**RE: Defining Area of Property Subject to Restrictions for the Vapor Intrusion Pathway
Former Sheller Globe Facility
3200 Main Street, Keokuk, Iowa
EPA RCRA ID # IAD005136023
MACTEC E&C Project No. 3250-04-5089.02**

RESPONSE TO COMMENTS

October 2007, Vapor Intrusion Screening
Former Sheller Globe Facility
3200 Main Street
Keokuk, Iowa
EPA RCRA ID No. IAD005136023

Review Comments Provided By: United States Environmental Protection Agency
Region VII, Kansas City, Kansas
Dated November 5, 2007

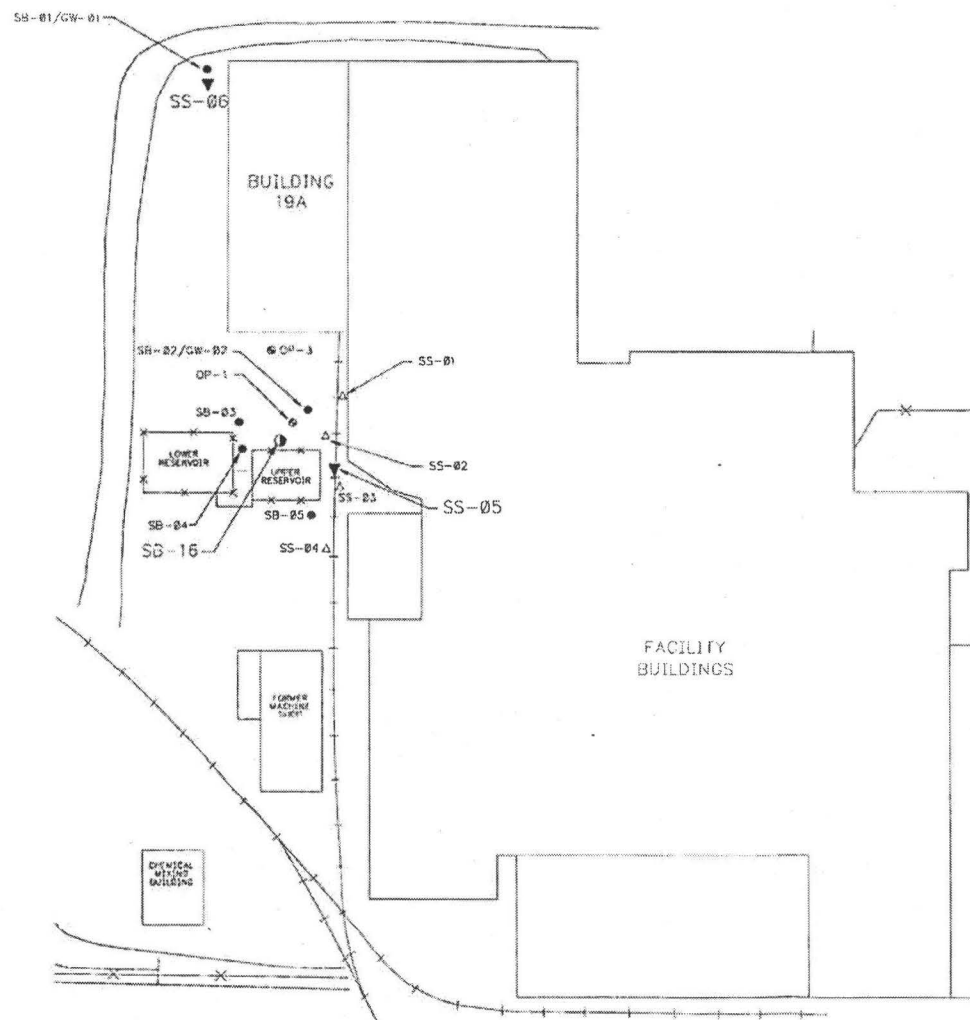
Comment 1) The groundwater buffer contour should represent a 100-foot buffer based on sampling locations with demonstrated contaminant concentrations below screen criteria. Please also be aware that contaminant concentrations in proximal fill and till monitoring wells may not represent a continuous plume. For example, monitoring well MW-13A (shallow well) should not be used to interpolate the leading edge of contamination observed in MW-13 (deeper well).

Comment 3) The lateral extent of contamination has not been delineated north and west of MW-7 and MW-8. If Metzler wishes to demonstrate that these areas of the property should not be subject to land use controls under current site conditions, these wells should be redeveloped and resampled to determine if concentrations have fallen below detectable levels since the last sampling event. Otherwise, additional groundwater monitoring locations should be proposed for EPA approval to delineate the extent of contamination of groundwater.

Additional groundwater data for wells located north of MW-7/MW-8 have been identified. This groundwater data, included as Attachment A to this response to comment letter, shows that VOCs were not detected in groundwater wells OP-1, OP-2, and OP-3, located to the north of MW-7/MW-8. Therefore, these wells provide a boundary on the extent of impact to the north of MW-7/MW-8. Similarly, well MW-17, located downgradient of MW-7, has shown non-detects for VOCs in recent rounds of groundwater sampling. The concentrations of VOCs in wells MW-7 and MW-8 are only marginally higher than vapor intrusion screening values. Collectively, this indicates that groundwater in the vicinity of MW-7/MW-8 does not represent a substantial source area of VOC impact. As discussed with USEPA during a teleconference on December 5, 2007, well locations OP-1 and MW-17 may be used to establish the restricted zone on the north and northwestern sides of the groundwater VOC impact. As discussed with USEPA during the December 5, 2007 teleconference call, wells MW-12, MW-6a/6B, MW-16, and MW-18 will be used to establish the restricted zone on the western and southern sides of the groundwater plume.

The attached figure identifies the restricted zone. The perimeter of the zone is based on:

- 100-feet from well MW-6A on the eastern side. This well is non-detect for VOCs. The facility building is upgradient of groundwater VOC impact.
- The property line on the southeastern and southern sides. The property line is separated from the area of groundwater impact with concentrations in excess of vapor intrusion screening values by monitoring wells that are non-detect for VOCs.

- 100-feet from well MW-17 on the western side. This well is non-detect for VOCs. However, because the groundwater movement is toward the southwest, a 100-foot buffer zone is established to ensure that residential structures would not be placed within the potential convective zone for vapor intrusion.

- The location of OP-1 on the northern side. Well OP-1 is non-detect for VOCs, and is located more than 100 feet upgradient of wells MW-7 and MW-8. Additionally, wells OP-2 and OP-3 are located north of OP-1 and were non-detect for VOCs.

The report will be revised to include a chem.-box figure for groundwater similar to Figure 2. In addition, the existing Figure 3 will be revised to show monitoring wells with concentrations greater than screening values, less than screening values, and non-detects. This will form the basis of the area to which the restrictive covenant will apply. The existing Figure 4 will be revised to show the expanded area of the restricted zone, as depicted in the attached figure.
